UNITED STATES PATENT AND TRADEMARK OFFICE

APPLICATION NO.	FILING DATE	FIRST NAMED INVENTOR	ATTORNEY DOCKET NO.	CONFIRMATION NO.
10/780,190	02/17/2004	Kueun Choi	ChoiKueun	9922

Office Action Summary

DETAILED ACTION

Fig. 12

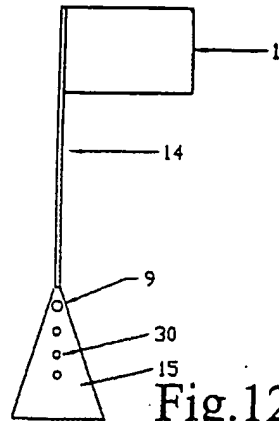
1. The replacement drawing sheet filed 06-30-2005 has not been approved as new Figs. 12 and 13 introduce new matter, namely the plurality of adjustment apertures (30) in Figs. 12, and the adjustment aperture (31) in Fig. 13.

substitute specification which is represented in new Figs. 12 and 13. Applicant is required to cancel the new matter in the reply to this Office Action.
